**From:** Economy, Kathleen [<mailto:Economy.Kathleen@epa.gov>]  
**Sent:** Thursday, July 30, 2015 2:25 PM  
**To:** Dana Bryson; Russ Patterson; George Basabilvazo; Frank Marcinowski; Doug Tonkay; Alton Harris; Chris Camphouse; Shoemaker, Paul E; Steve Kouba  
**Cc:** Perrin, Alan; Edwards, Jonathan; Maestas, Ricardo, NMENV; Stone, Nick; Peake, Tom  
**Subject:** 4th Set of CRA 2014 Completeness Comments

### FOURTH SET OF EPA COMPLETENESS COMMENTS FOR CRA 2014

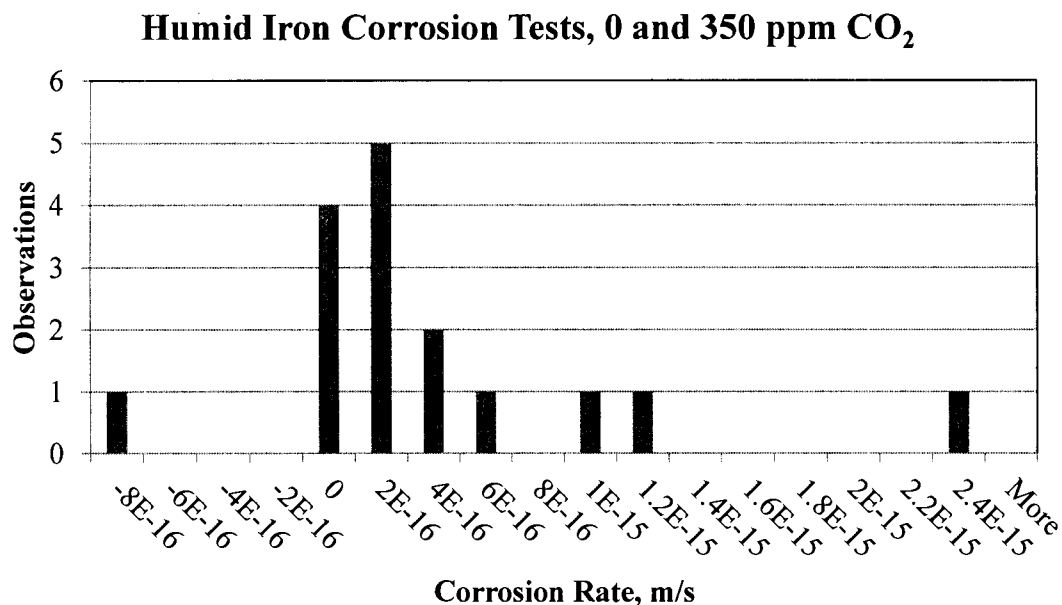
and without organic ligands, and for partially and fully immersed coupons. This range includes the predicted CO<sub>2</sub> gas concentrations of 3.2 ppm. The corrosion rates determined by Roselle (2013) for experiments at 0 and 350 ppm CO<sub>2</sub> concentrations are summarized in the figure below. The collective results from these experiments indicate corrosion does occur above 0 ppm and up to 350 ppm CO<sub>2</sub> and corroborate relevant data that indicates corrosion will occur at CO<sub>2</sub> concentrations above 0 ppm.

Please provide a justification for why the experimental corrosion data gathered from experiments above 0 ppm CO<sub>2</sub> concentrations were not included in the development of the parameter CORRMCO<sub>2</sub>.
